FINAL PLAT OF
"MARIE'S MEADOW"
SEDGWICK COUNTY, KANSAS
IN THE NORTHWEST QUARTER OF SECTION 4,
TOWNSHIP 28 SOUTH, RANGE 2 WEST OF THE 6TH P.M.

RE: SUB 2003-20 -- One-Step Final Plat of Le' Marie Addition

RE: SUB 2003-20 -- One-Step Final Plat of Le' Marie Estates Addition

CASE NUMBER: SUB 2003-20 -- LE' MARIE ESTATES

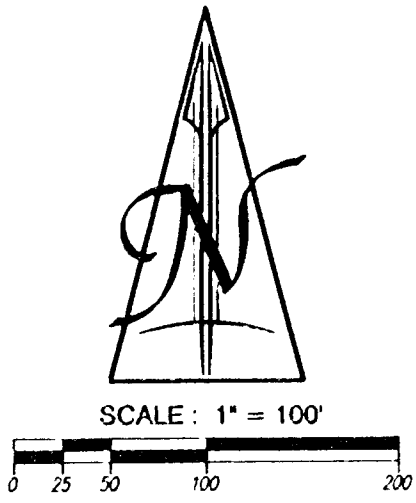
- A. Since sanitary sewer is unavailable to serve this property, the applicant shall contact **County Code Enforcement** to find out what tests may be necessary and what standards are to be met for approval of on-site sewerage facilities. A memorandum shall be obtained specifying approval. *The applicant needs to contact County Code Enforcement concerning sewer and water requirements.*

- E. **County Engineering** needs to comment on the status of the applicant's drainage concept. *A drainage plan is needed. The drainage plan needs to address effect of terraces. A flood study is needed. Minimum pads need to be set for lots 9 through 15, based on flood study.*

- F. **County Engineering** needs to comment on the access controls. The plat denotes complete access control to 23rd St. for Lots 1 and 14. *Access control except one opening shall be dedicated for Lot 15. Complete access control is needed along the north 75 feet of the west line of lot 1 and the north 75 feet of the east line of Lot 14.*

- G. County Engineering has requested a guarantee for removal of field entrances on Lot 1 & 14.
- H. The applicant shall guarantee the installation of the proposed street to the 36-ft rock suburban street standard.

- I. County Fire Department/County Engineering needs to comment on the street length of the proposed cul-de-sac (2,300 feet). Rural cul-de-sacs over 1,200 feet in length must provide a stub street connection or contingent street dedication providing future access to adjoining tracts, or an emergency access easement. **A contingent street dedication is needed between Lots 7 and 8.**

- J. County Engineering requests a contingent dedication of street right-of-way between Lots 7 & 8 in order to provide potential street connection to adjoining properties. On the final plat, the contingent dedication of right-of-way needs to be referenced in the platting text.

- K. The drainage easement between Lots 8 & 9 should be increased to 40 feet.
- L. The applicant is reminded that this site is located within three miles of the City Limits of Wichita and will be heard by City Council. Therefore, the City Council signature block needs to be included on the final plat.

- O. The applicant needs to assign a name for the new street. **Leo Circle will be the street name.**
- P. The floodway reserve within Lot 15 shall be denoted by a dashed line.

- S. The platting text shall include language that a drainage plan has been developed for the plat and that all drainage easements, rights-of-way, or reserves shall remain at established grades or as modified with the approval of the applicable City or County Engineer, and unobstructed to allow for the conveyance of stormwater.

- AA. The representatives from the utility companies should be prepared to comment on the need for any additional utility easements to be platted on this property. **SBC has requested additional easements.**
